PCN #: 2619

PCN Title: Qualification of Additional Clip Bonding, Lead Frame Structure (Matrix) and Mold Compound for Select Automotive Products

PRODUCT CHANGE NOTICE**PCN-2619 REV1**

Figure 1: Comparison of SMAF (D-FLAT) Package Construction for SKY and GPP products

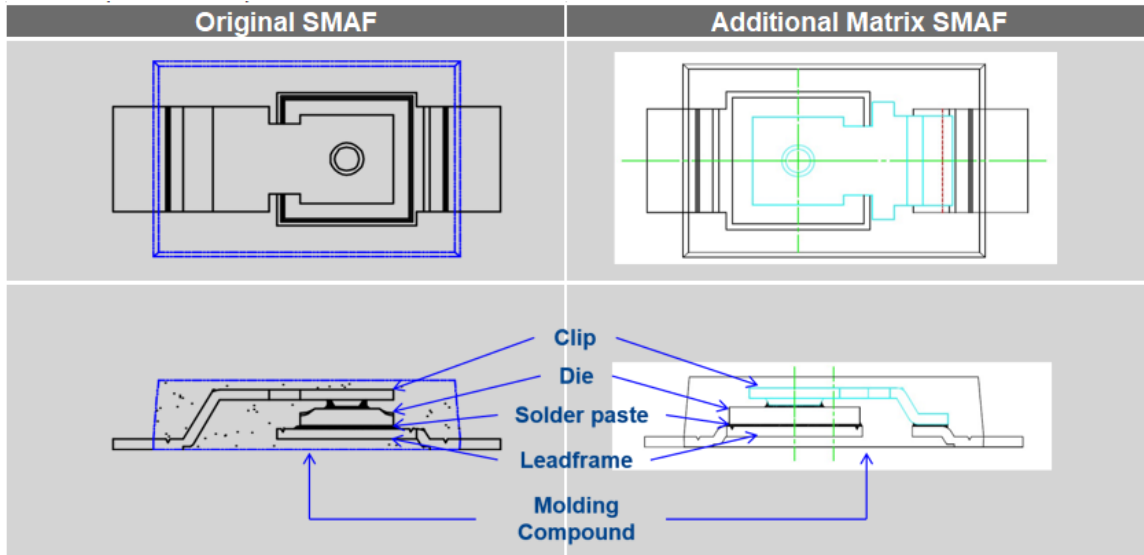
IMPACT				
No change in datasheet parameters and product performance.				
PRODUCTS AFFECTED				
Please refer to Table 1 for the affected automotive products and Figures for comparison of package construction below				
WEB LINKS				
Manufacturer's Notice:	https://www.diodes.com/quality/product-change-notices/diodes-product-change-notices/			
For More Information Contact:	https://www.diodes.com/about/contact-us/contact-sales/			
Data Sheet:	https://www.diodes.com/catalog/			
DISCLAIMER				
Unless a Diodes Incorporated Sales representative is contacted in writing within 30 days of the posting of this notice, all changes described in this announcement are considered approved.
